LAND USE APPLICATION SUMMARY

Property Location: 1708-1714 W Lake Street
Project Name: Seventeen10
Prepared By: [Kimberly Holien](#), Senior Planner, (612) 673-2402
Applicant: Seventeen10, LLC
Project Contact: Scott England, DJR Architecture
Request: To construct a four-story mixed-use building with seven dwelling units.
Required Applications:

Conditional Use Permit	To increase the height of a building in the SH, Shoreland Overlay district from 2.5 stories or 35 feet to four stories, 49'10".
Site Plan Review	For the construction of a four-story, mixed use building with seven dwelling units.

D1 FLOOR PLAN - PARKING LEVEL
1/8" = 1'-0"

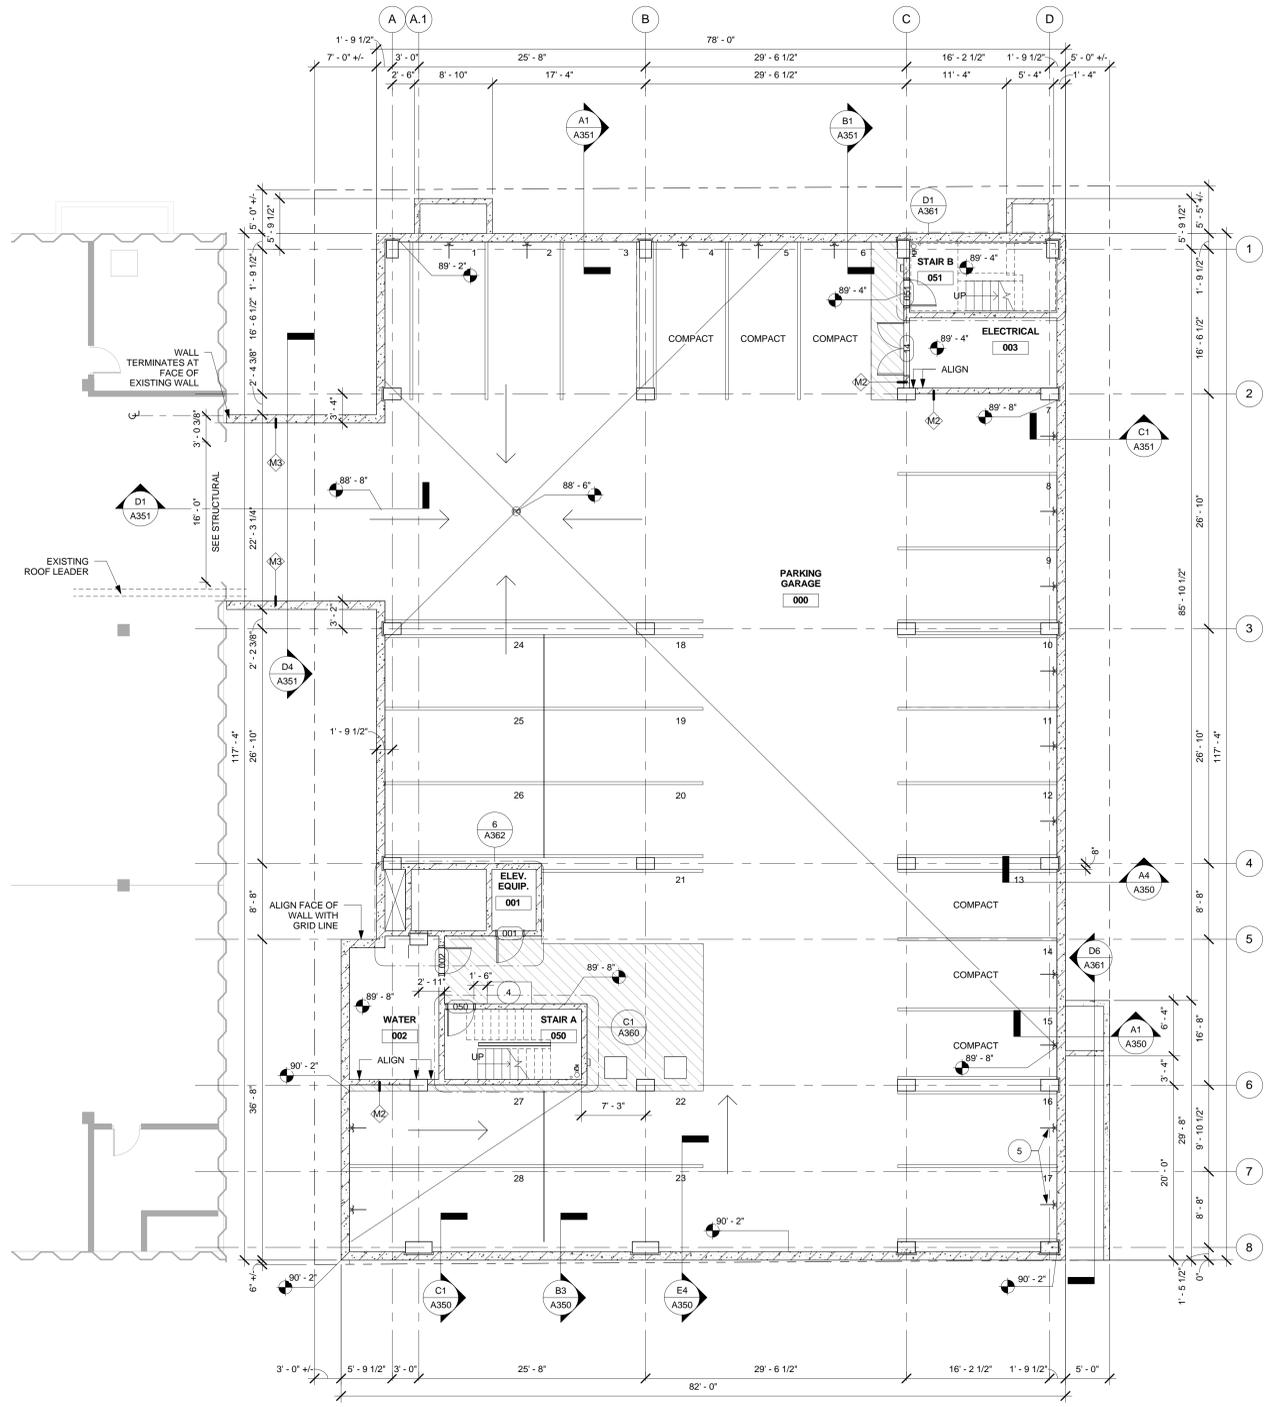
- It appears that the connection between the lower level parking areas on the properties, shown on Sheet A100, would impact a portion of the existing underground stormwater storage system on the adjacent property. Any impacts to the system should be evaluated and identified to ensure the site is still in compliance with the stormwater treatment requirement of Chapter 54.

LANDSCAPE PLAN

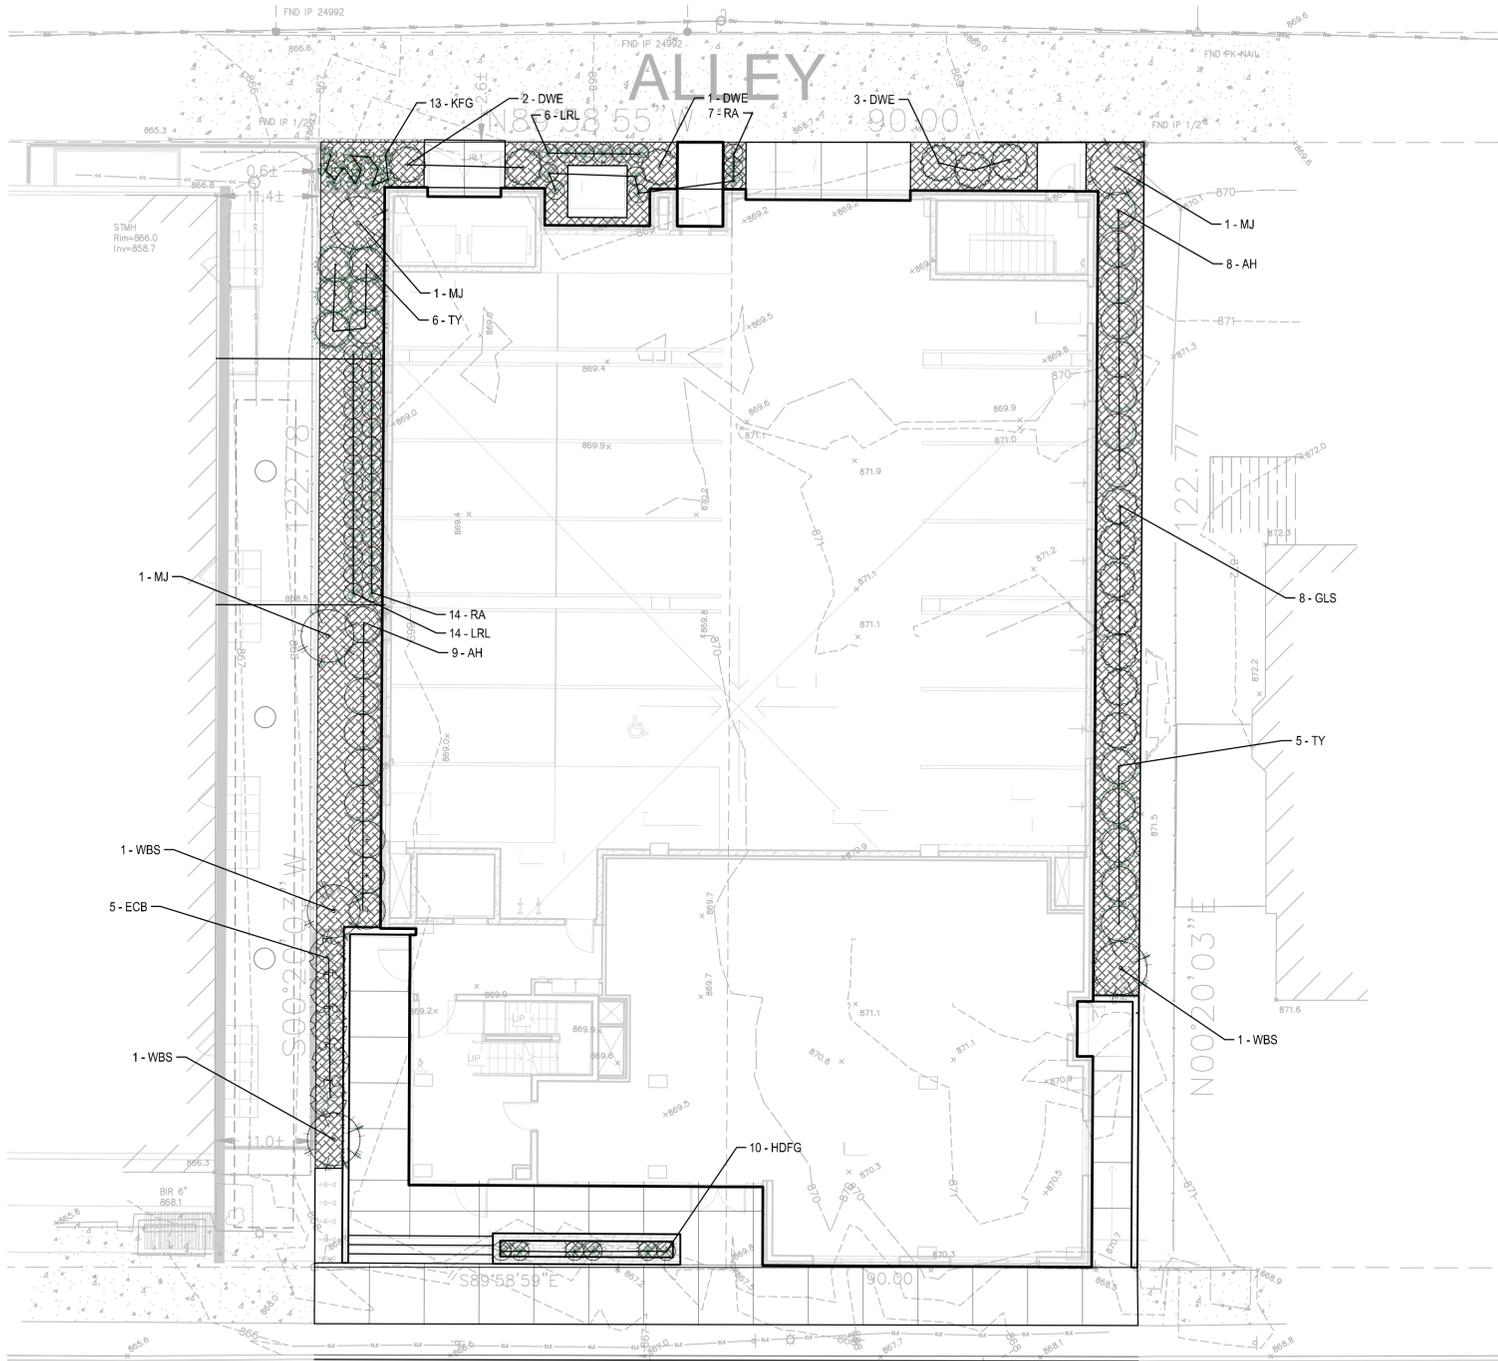
- **Minimum tree planting requirement.** The site is required to have one canopy tree. In lieu of a canopy tree the applicant is proposing three evergreen trees. Staff recommends accepting evergreen trees in lieu of canopy trees and granting alternative compliance. Alternative compliance for this requirement was previously granted by the City Planning Commission.
